TECHNICAL BULLETIN No. 44 DATE: 23/05/00

SUBJECT: Microwave Oven Switch

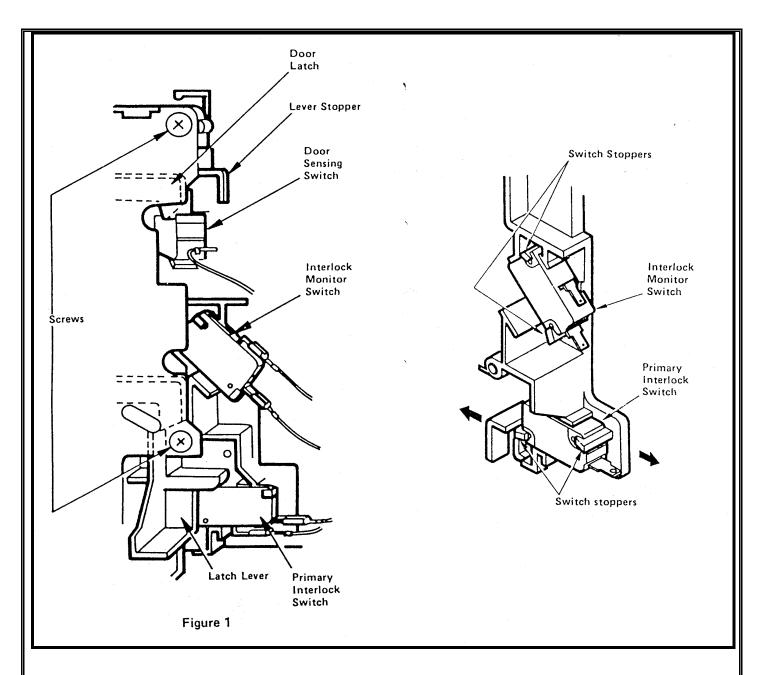
Fault: The oven does not heat, or the Blower Motor and Turntable is running when the door is open.

Cause: The silicon oil, used to lubricate the Latch Lever, is damaging the Primary Interlock Switch. It is penetrating the switch and makes the contacts high resistant and the switch body soft.

Remedy: Clean off the silicon oil from the Latch Lever, and replace the Primary Interlock Switch with a new one, which has these markings: YAMATAKE V5930D, Part No. 617 152 4741.

- 1. Disconnect the Power Supply Cord from the wall outlet.
- 2. Remove the Cabinet.
- 3. Disconnect all the wires from the Primary Interlock Switch.
- 4. Loose the two (2) screws holding the Lever Stopper and remove the Latch Lever.

- 5. Remove the Primary Interlock Switch by pulling it toward you and at the same time pushing the Switch Stoppers apart to make a gap between the switch body and the Catches.

- 6. Clean off the silicon oil completely from the Latch Lever, especially from its underside and from the Lever Stopper with a soft cloth.
- 7. Insert a new switch by pushing one end of it against the rear Switch Stopper until the other side reaches the slope of the other Switch Stopper, then push down to click it into place.

- 8. Reassemble the Latch Lever, tighten the two screws holding the Lever Stopper and reconnect the wires to the switch.
- 9. Replace the Cabinet, and test the oven for all functions and safety.
